Group Northwest, Inc.

G-5333

Subject: **ADDENDUM LETTER**
Proposed New Residence
6300 Webster Way
Mukilteo, Washington 98275

Plate 1 – Site Plan

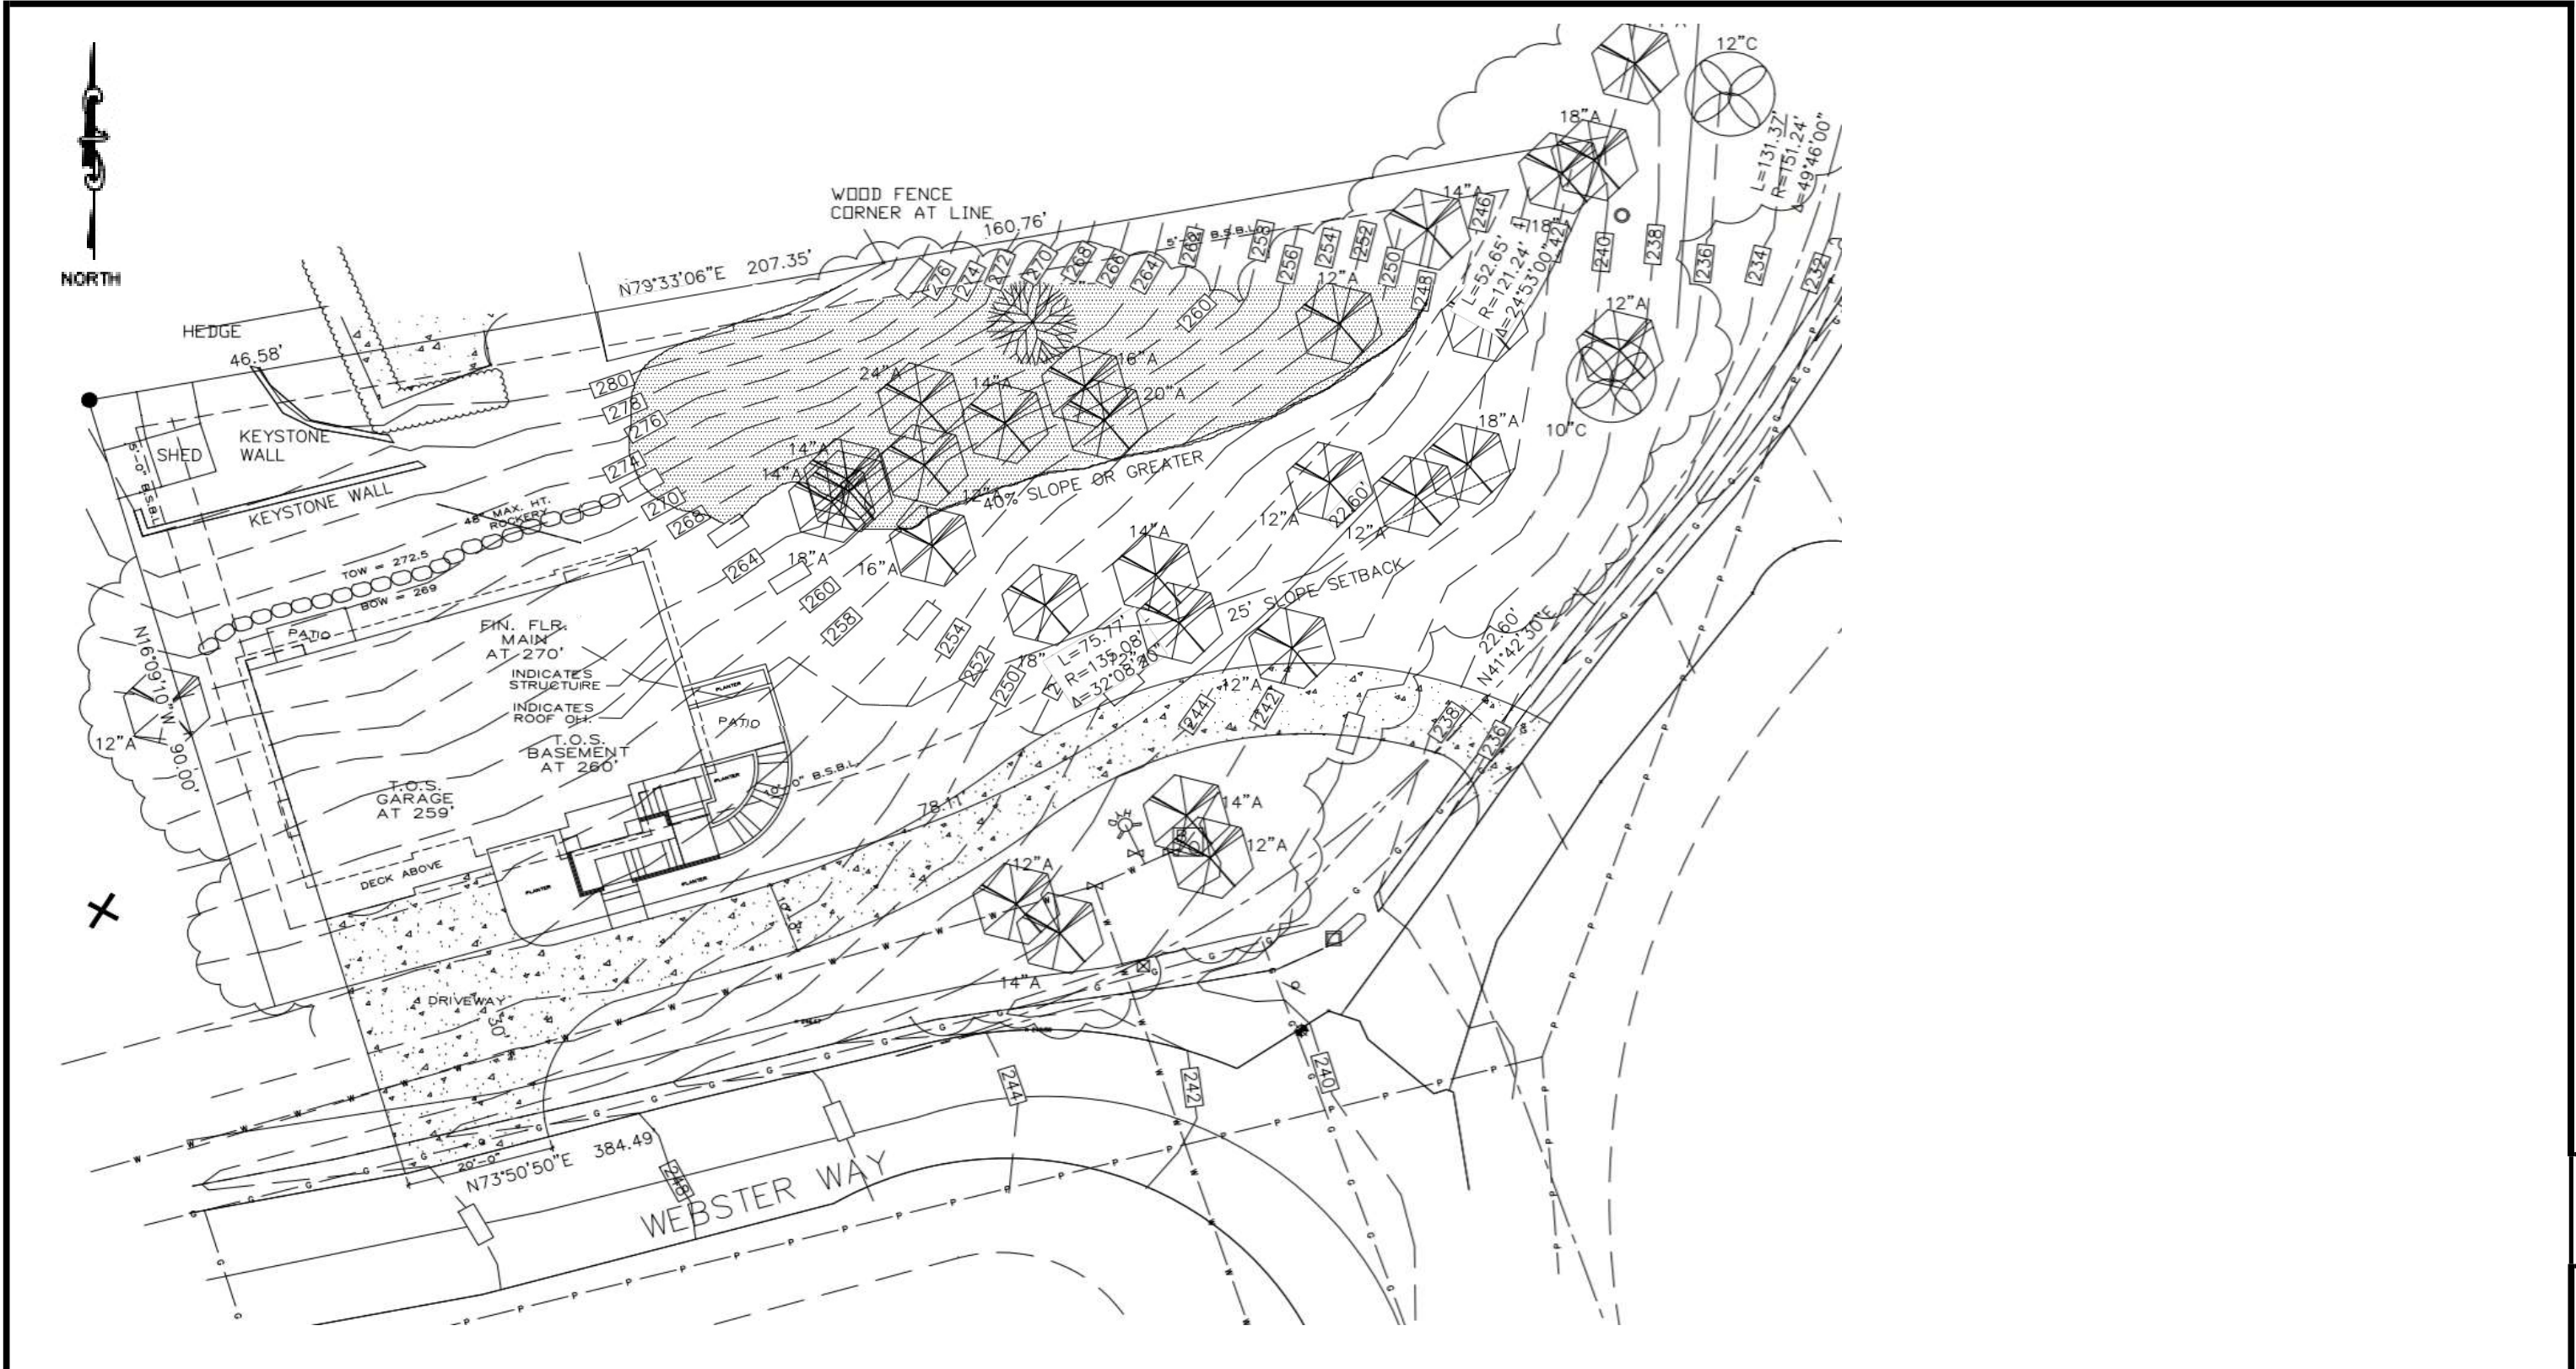
Based on the information provided, we understand that you are proposing to develop the west section of the existing vacant lot with the construction of a new two-story single-family residence with a south-facing daylight basement and attached garage. The garage will be accessible by a driveway that begins east of the intersection of Webster Way and 63rd Place W and runs parallel to the south property line towards the residence along gradually sloped topography. The residence will have a footprint of approximately 1700 square feet, with a total interior living space of 4,000 square feet within the three floors. We understand that excavations into the existing slope at the west section of the property will be required for the construction of the new residence, but this section of the property is not mapped as a steep slope. As noted in the above-referenced geotechnical report, the site contains steep to very steep slopes within the central and northeast areas and therefore is considered a Geologic Sensitive Area. The existing steep slope and the footprint of the proposed residence are illustrated in in Plate 1 – Site Plan.

The geotechnical report concluded that site disturbance for the new residence is acceptable up to the edge of the steep slope area, but that a setback distance of 10 feet from the slope should be implemented regardless. The project plans indicate that the proposed footprint of the residence will be located no less than 10 feet from the edge of the steep slope, and that the driveway area will be located more than 25 feet away from the bottom of the steep slope. It is our opinion that the reduced setback will not cause any adverse impacts to the steep slope area at the central and northeast sections of the property.

Based on the site conditions observed and our review of the project plans, it is our opinion that the recommendations outlined in the above-referenced geotechnical report have been properly implemented into the design of the proposed new single-family residence. The plans show that the residence will be located at the west section of the property where the topography does not contain any critical slopes with inclinations greater than 40%, and that site development will not occur within a setback distance of 10 feet from the western edge of the steep slope. In our opinion, these plans will not adversely impact the steep slope or the adjacent properties to the north and west.
